Notice to all Bidders

RE: CLARIFICATION NO. 3

Contract Title: Design, supply, installation and commissioning of the 400/220 kV Kimuka Substation and Associated Transmission Lines

Contract No.: KE-KETRACO-416094-CW-RFB

Section-VII-2B-Kimuka-400-220kV-SS-LLOs-All Drawing

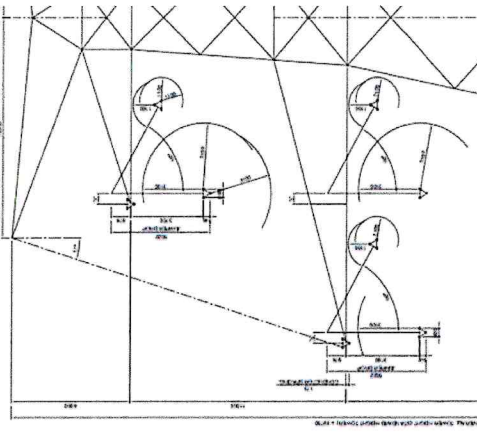
1. In Section-VII-2B-Specification page 413, the clearance for suspension insulator string is 3600mm on 0-10° swing, and 1200mm on 65 swing. What if the actual swing angle between 10°-65°, the clearance should be?

2. In Section-VII-2B-Kimuka-400-220kV-SS-LLOs-All Drawing shown, the clearance for 0-10° and 65° swing is 3100 mm and 1100mm. It's different between drawings and specification. Which one should be followed?

Refer to item no. 62 of this clarification
